Styrax Fashions Ltd Plot 180

PLOT NO-180, DEPZ-EXTN GANAKBARI, SAVAR, DHAKA

14 May 2025

Observation 2: Discrepancy between the as-built drawing and onsite condition (Main Operation Building).

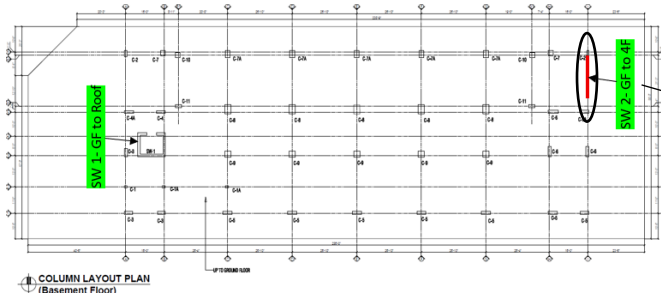
Description: During the inspection, it was observed that SW 2 is shown in the provided as-built drawing only up to the 2nd floor, where it extends to the 4th floor. The building engineer is required to survey the full structure and update the drawing and design documents based on the as-constructed structure.

Observation 3: Non-structural elements are not anchored. (Main Operation Building).

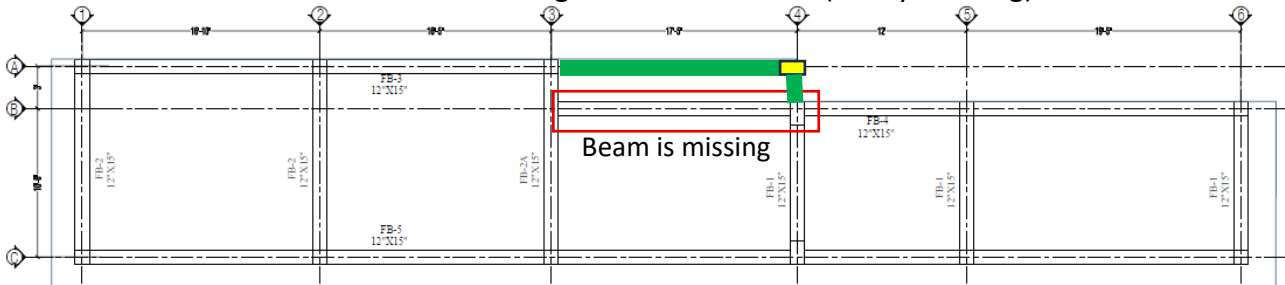
Description: Non-structural elements are not anchored at several places on the floor. The building engineer is required to anchor or brace all the non-structural elements (Racks/water tank) adequately.
